Cross Section & Case Study Review Memorandum

To	Shelley Bennett (CoPP), Alex Robinson (CoM)		
Copy to	Theodora Hogan (Melbourne Water), Todd Berry (DELWP)		
From	David Howard	Tel	+61 3 8687 8789
Subject	Fishermans Bend Streetscape Case Study Review	Job no.	3136555

Fishermans Bend Drainage Strategy – Case Study Review

GREEN STREET
 ALTERNATE
 CONFIGURATION
 SK01.
 NTS GHDW.
 5.10.2018.

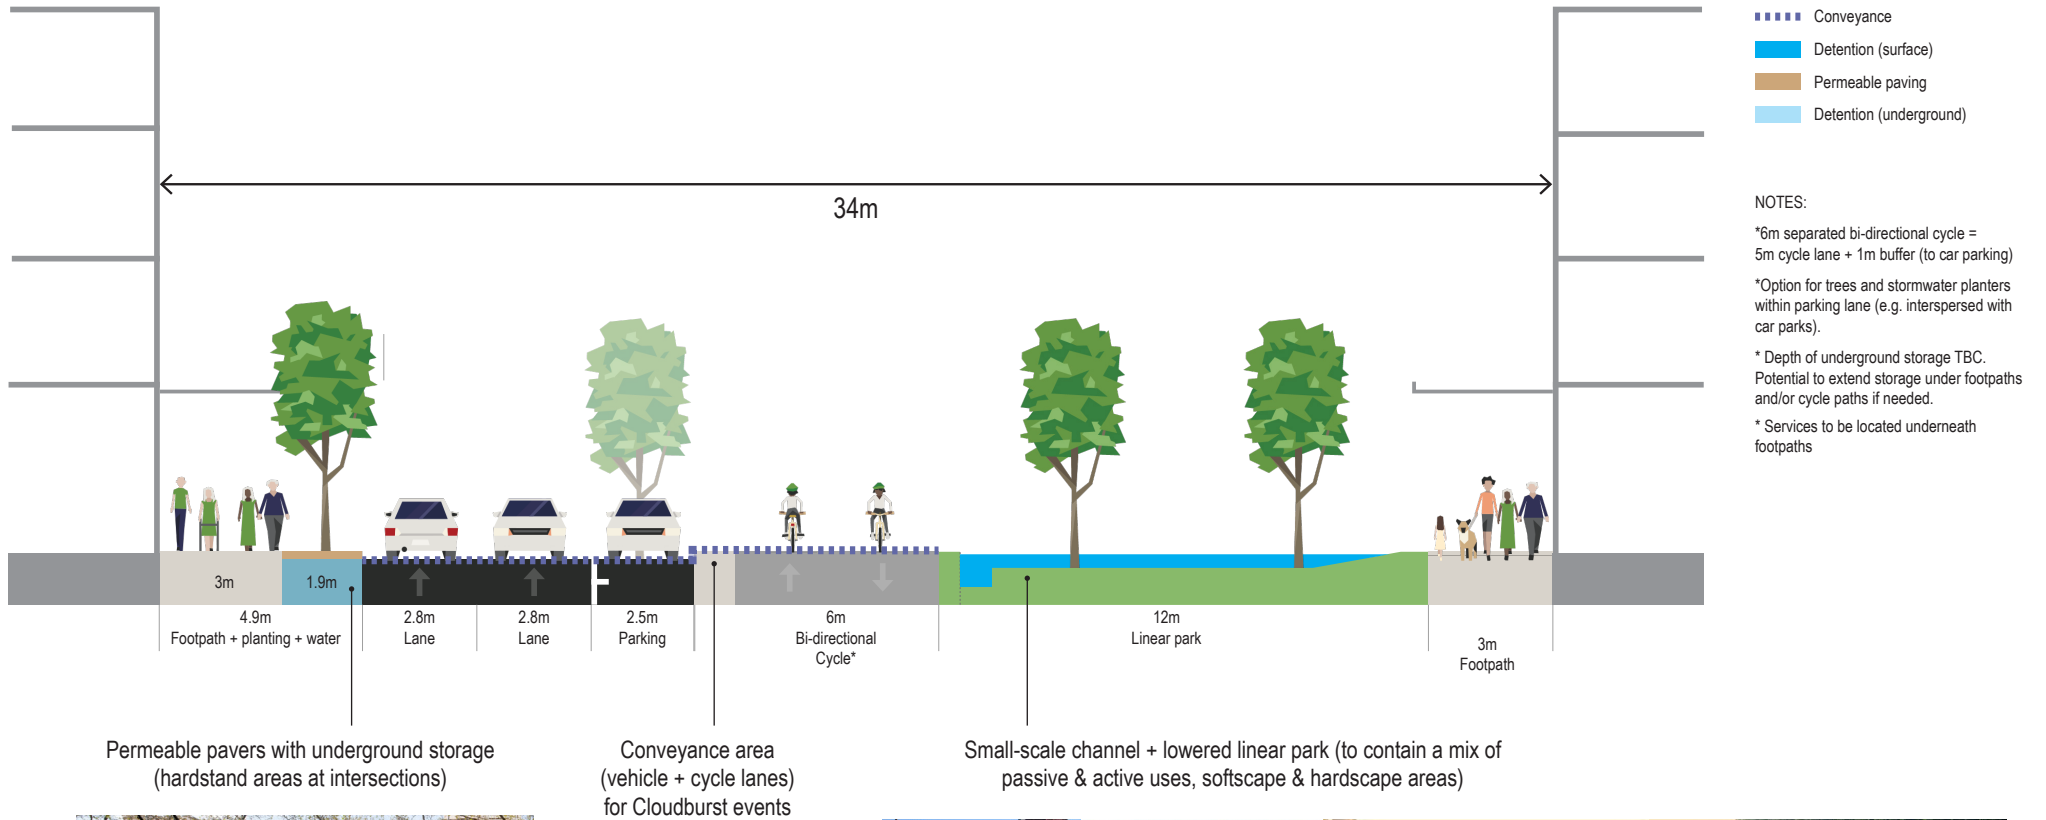
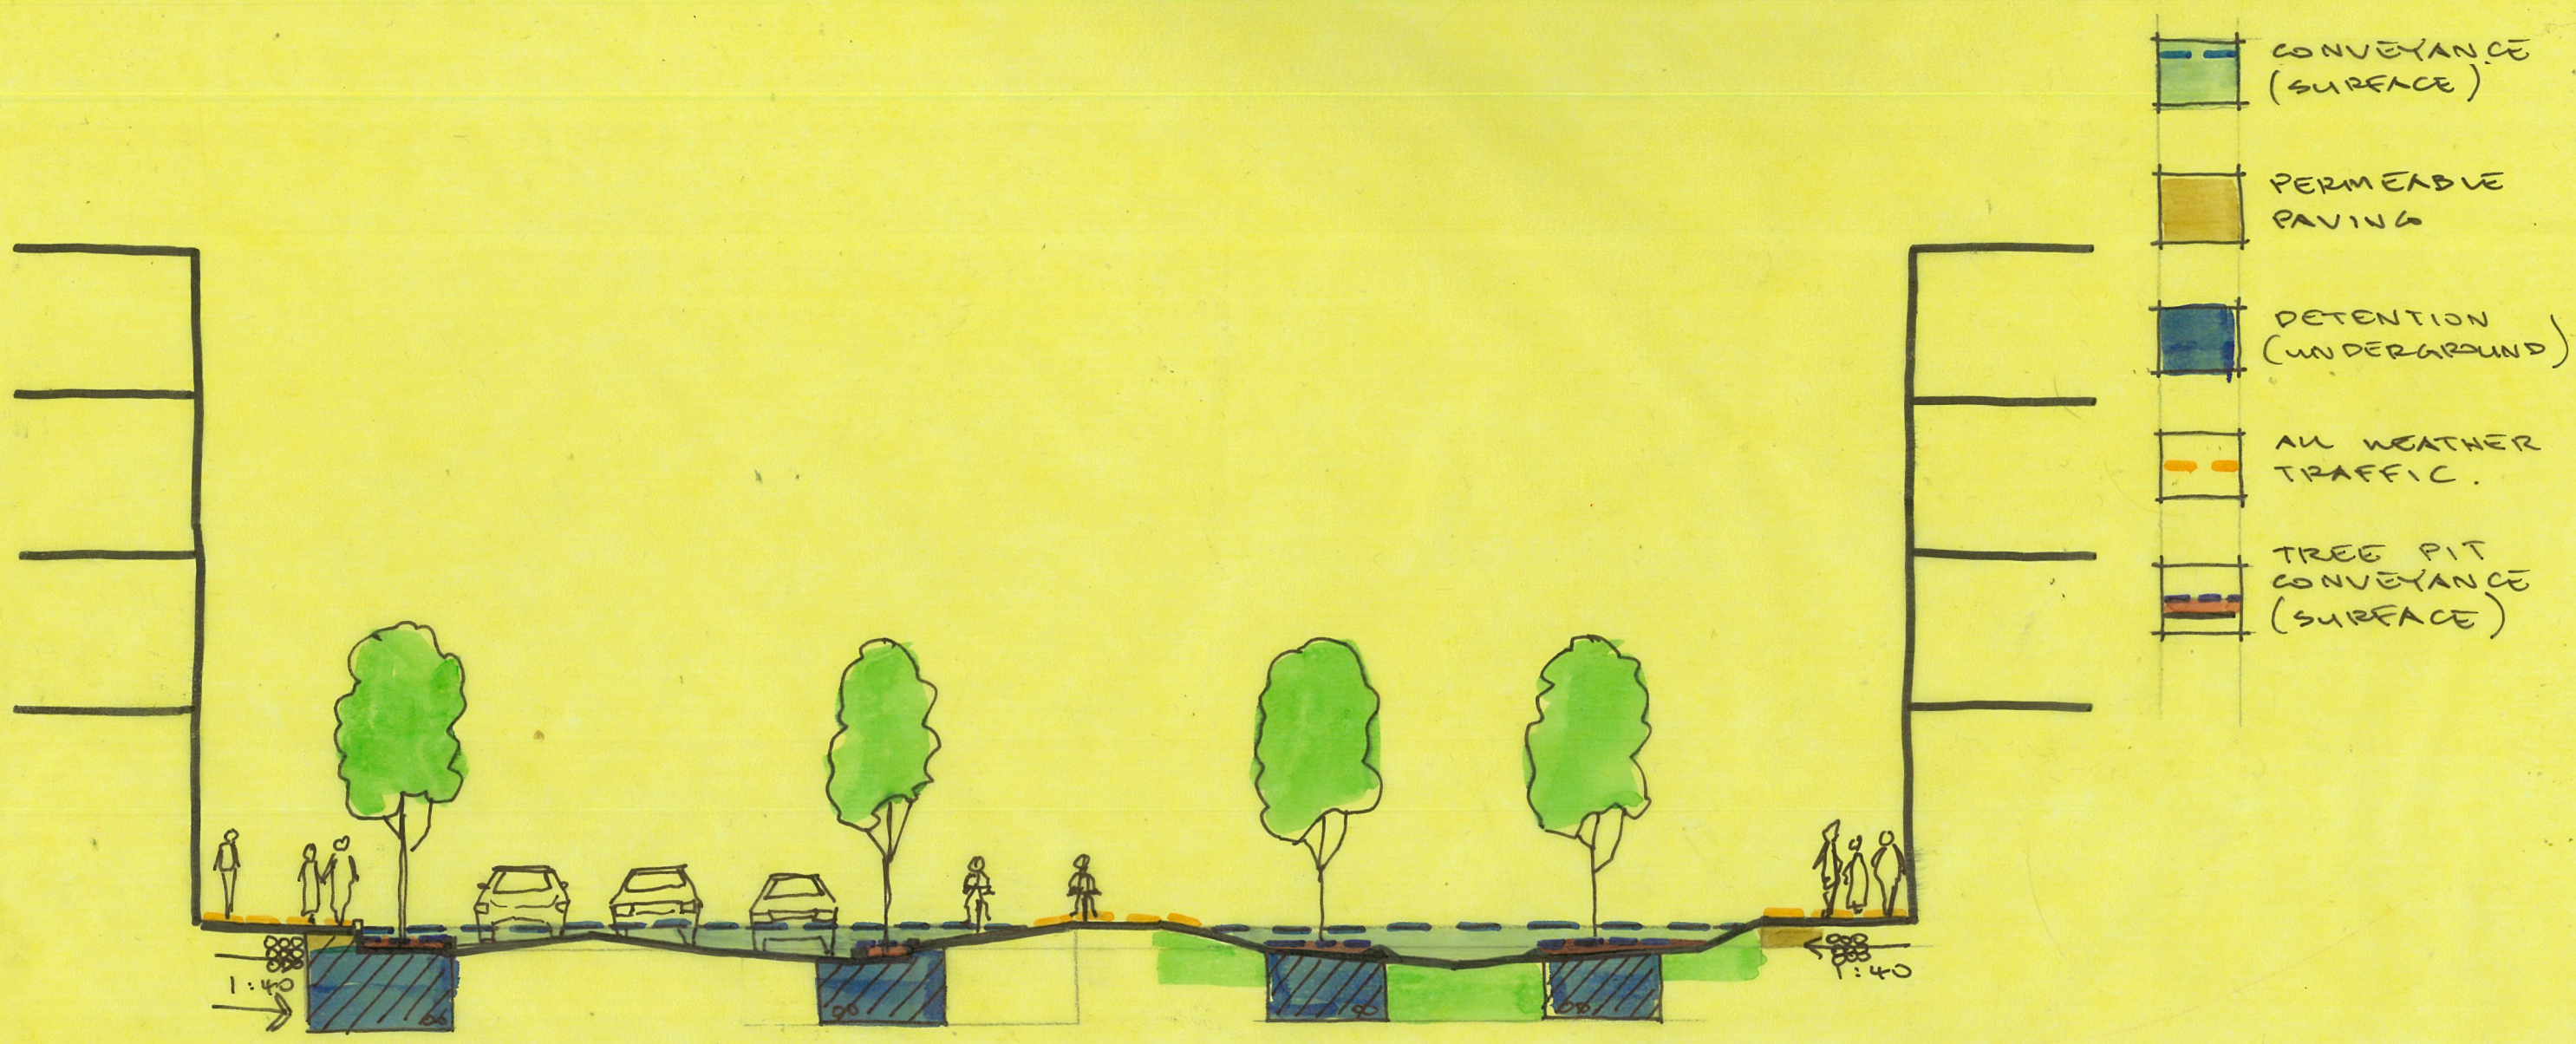
Refer to the attached Graham St cross section for a before and after comparison of how the streetscape drainage functionality, vertical depth of detention systems, streetscape cross-falls/grades/drop-offs, and conflict with existing/future provision of services can be improved.

A detention area exceeding the 3.2 sq m target can be provided (based on Ramboll green street detention interpretation).

A conveyance area equivalent to 10 sq m can be provided (in accordance with GHD modelled area), and is based on:

- Tree pits/raingardens providing an average 400 mm of conveyance (1.66 sq m);
- Road and parking bay providing an average 350 mm of conveyance (2.84 sq m);
- Cycle path providing an average 325 mm of conveyance (1.95 sq m); and
- Linear park providing an average 350 mm of conveyance (3.60 sq m).

The maximum allowable depth of flooding was assumed to be 400 mm at any one point in the streetscape.

GREEN STREET
GRAHAM ST - GREEN ST
(34M W LINEAR PARK)

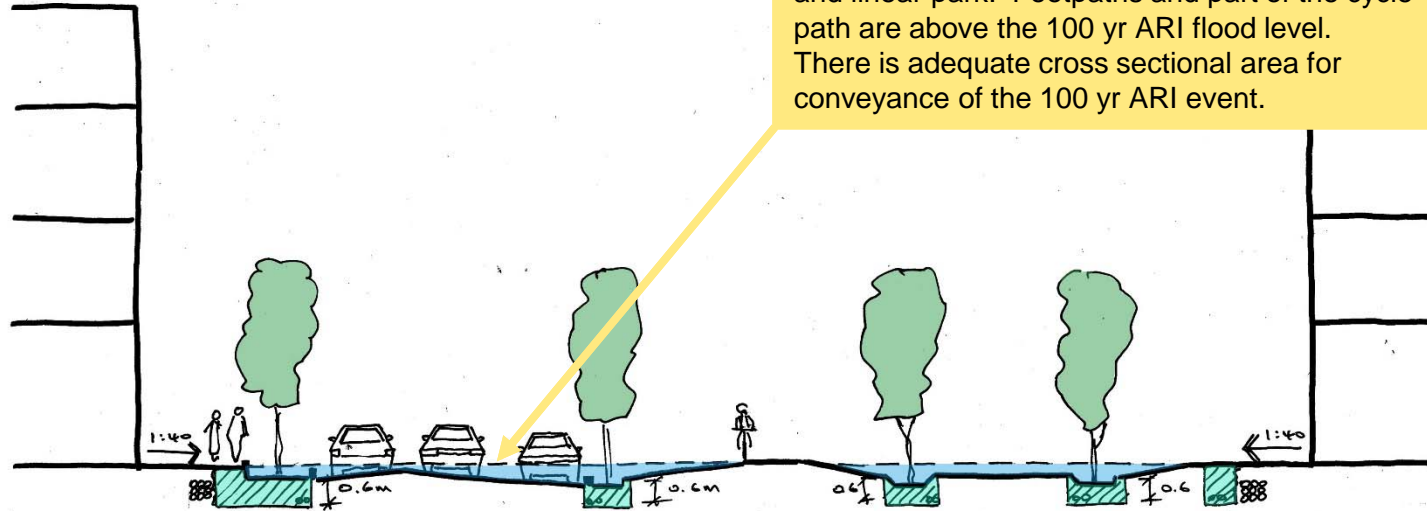
The 100 yr ARI flood event is confined to road and linear park. Footpaths and part of the cycle path are above the 100 yr ARI flood level. There is adequate cross sectional area for conveyance of the 100 yr ARI event.

- ALL TREE PITS \geq 2NO. MIN. ARI FOR CONVEYANCE
- COMBINED UTILITY CORRIDOR IN FOOTPATHS, \geq ROOT CONTROL BARRIER SEPERATION BETWEEN TREE PITS & UTILITIES. PROPOSED UTILITIES TO BE LOCATED 3-4M FROM BUILDING LINES.
- FOOTPATHS TO HAVE 1M MIN. PERMEABLE PAVING BEHIND KERB.
- TREE PITS \geq CELLS OR STRUCTURAL SOIL AS PER CITY OF TORONTO "BEST PRACTICE MANUAL." (2013)
- DETENTION \approx 3.6m² (TARGET 3.2m² BASED ON RAMBOLD BREAKDOWN)
- CONVEYANCE \approx 10m² BASED ON (A) TREEPIT / RAINGARDENS AVG. 400MM / 1.66m²
(B) ROAD AVG. 350MM / 2.84m²
(C) CYCLE PATH AVG. 325MM / 1.95m²
(D) LINEAR PARK AVG. 350MM / 3.60m².

GREEN STREET
GRAHAM ST - GREEN ST
(34M W LINEAR PARK)

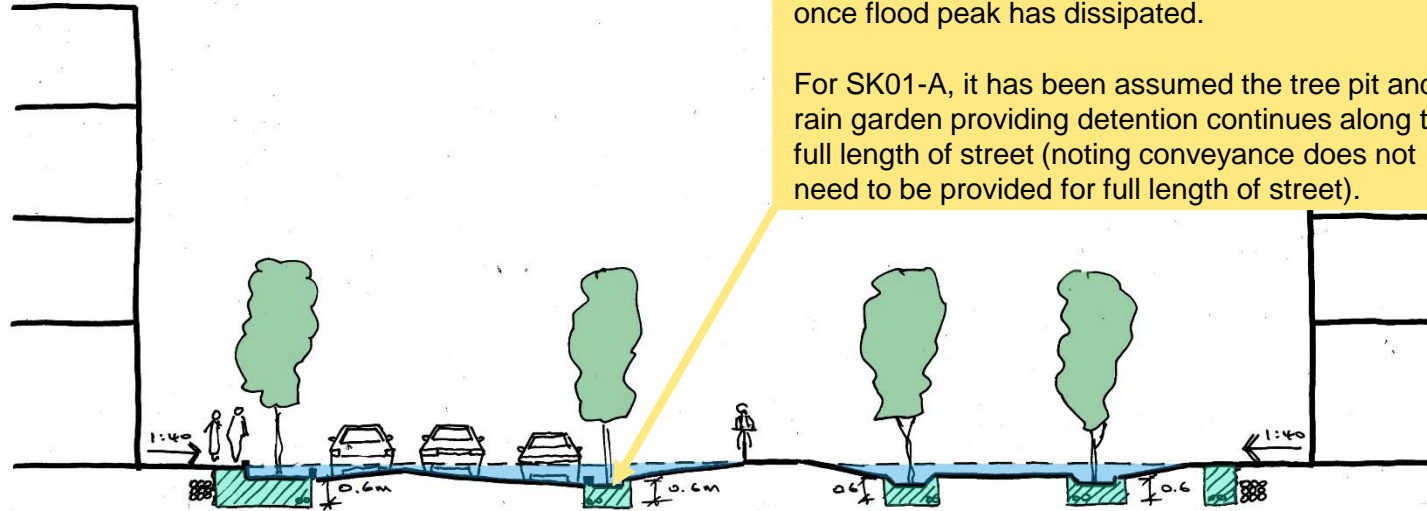
Tree pits provide conveyance and detention (assuming gravel backfill below root ball in lined storage). Tree pit detention free drains via ag lines once flood peak has dissipated.

For SK01-A, it has been assumed the tree pit and/or rain garden providing detention continues along the full length of street (noting conveyance does not need to be provided for full length of street).

**GREEN STREET
GRAHAM ST - GREEN ST
(34M W LINEAR PARK)**

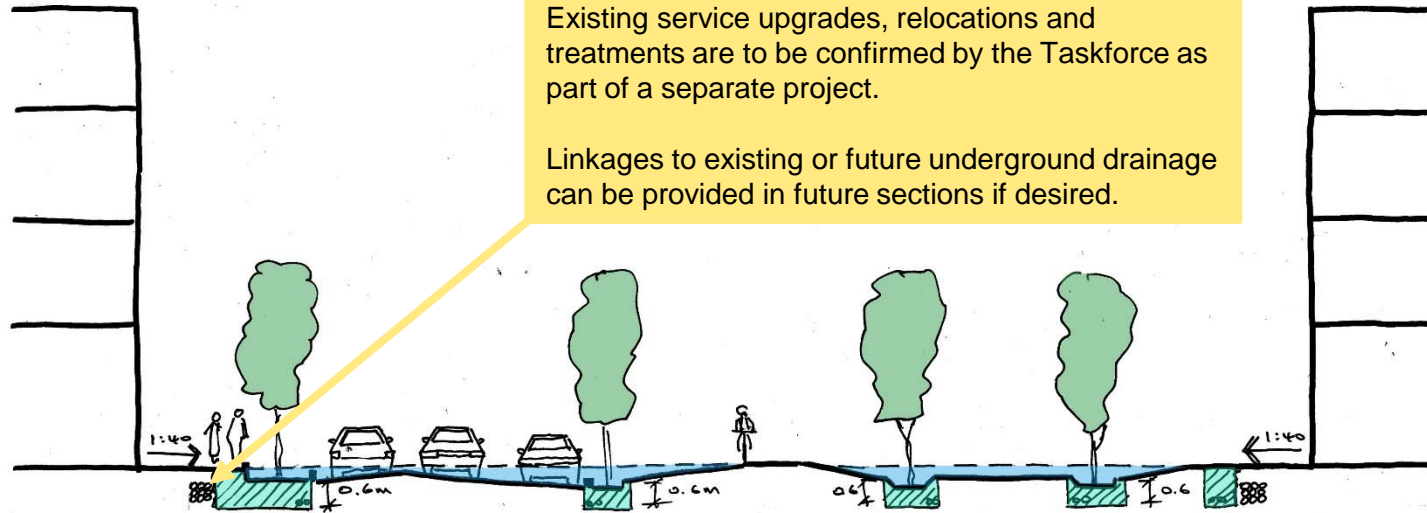
Existing service upgrades, relocations and treatments are to be confirmed by the Taskforce as part of a separate project.

Linkages to existing or future underground drainage can be provided in future sections if desired.

GREEN STREET (ALTERNATE GENERAL ARRANGEMENT)
 GRAHAM ST - GREEN ST
 (34 M W LINEAR PARK.)

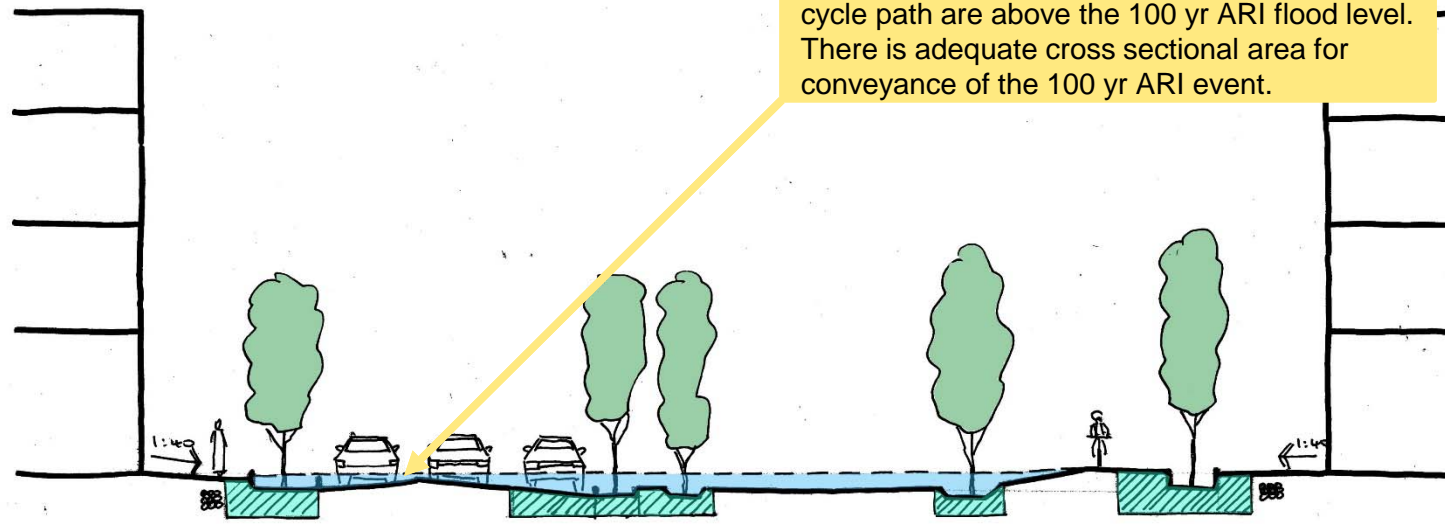
The 100 yr ARI flood event is confined to road and linear park. Footpaths and part of the cycle path are above the 100 yr ARI flood level. There is adequate cross sectional area for conveyance of the 100 yr ARI event.

GREEN STREET (ALTERNATE GENERAL ARRANGEMENT) GRAHAM ST - GREEN ST (34 M W LINEAR PARK.)

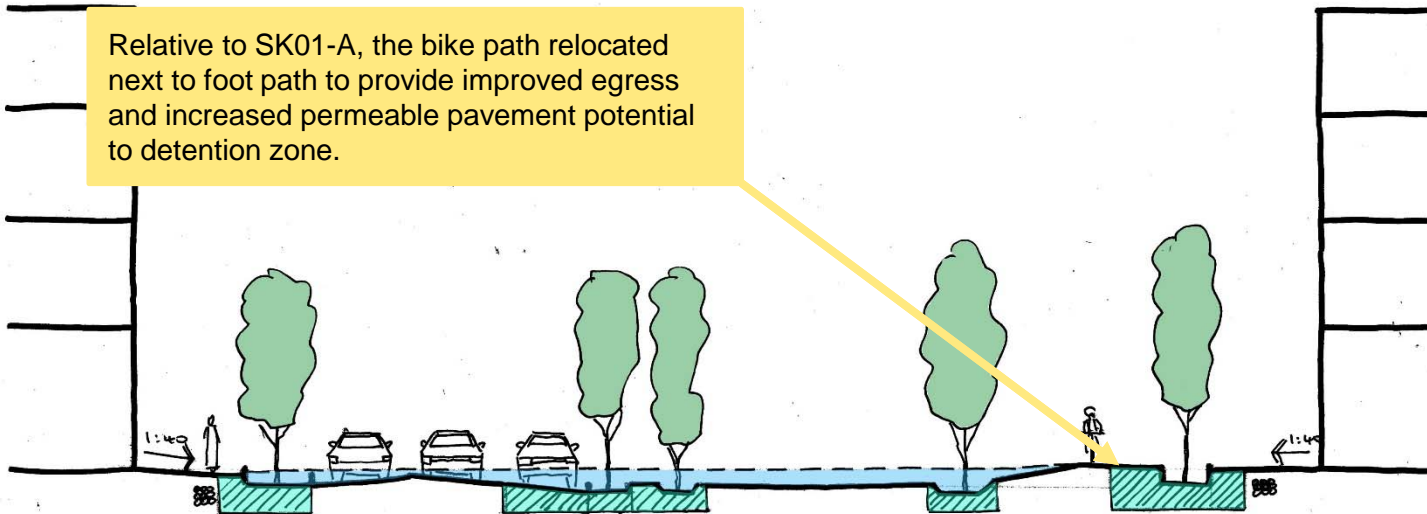
Relative to SK01-A, the bike path relocated next to foot path to provide improved egress and increased permeable pavement potential to detention zone.
